RE: 6-8-2022 MEETING AGENDA ITEM #1

CONSIDERATION AR22-0001 ARCHITECTURAL REVIEW APPLICATION

CPAH PLAMBECK GARDENS HIGH DENSITY RESIDENTIAL HOUSING

FROM: JOHN & GRACE LUCINI

SHEET C3.01 STORMWATER PLAN- SOUTHWEST- CLOSE UP DETAILS

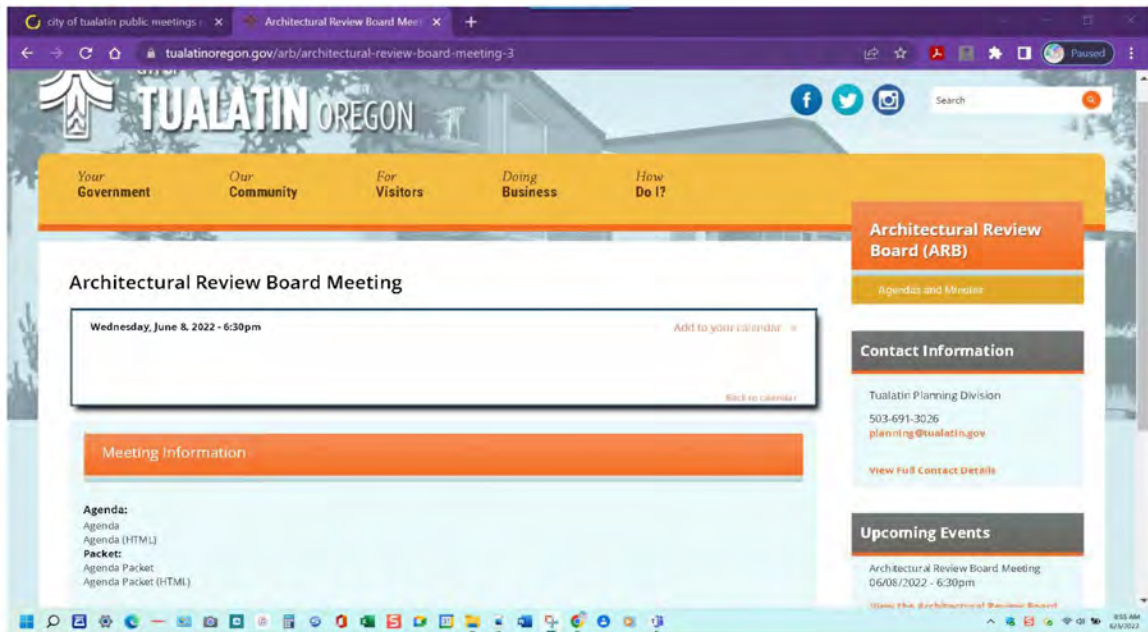
The SW Stormwater Plan Map 3.01 provided with the ARB submission does not provide information as to the location or diameter of the existing pipes referenced in the Drainage Plan- which is necessary to understand how CPAH is intending to convey stormwater runoff or overflow from the southern half of their property.

In addition, the SW Stormwater Plan Map 3.01 indicates use of a " connection to new public stormwater main"

Please provide clarification as to which and where CPAH is intending to discharge the southern stormwater

1. Will an existing pipe be used (as stated in the Drainage Report 5-2-22)?

A. If so, please clearly identify which one of the existing pipes will be used to convey the stormwater flow from the southern portion of the CPAP property offsite.

B. Please clearly identify where this pipe discharges.

4. As the stormwater flow from the southern portion of the CPAH property flows south, Plan Sheet C3.01 indicates intake connections of stormwater runoff from the southern parking area centrally located in the parking area.

How does CPAH plan to collect the parking lot runoff south of these two intakes into the proposed system which is uphill?
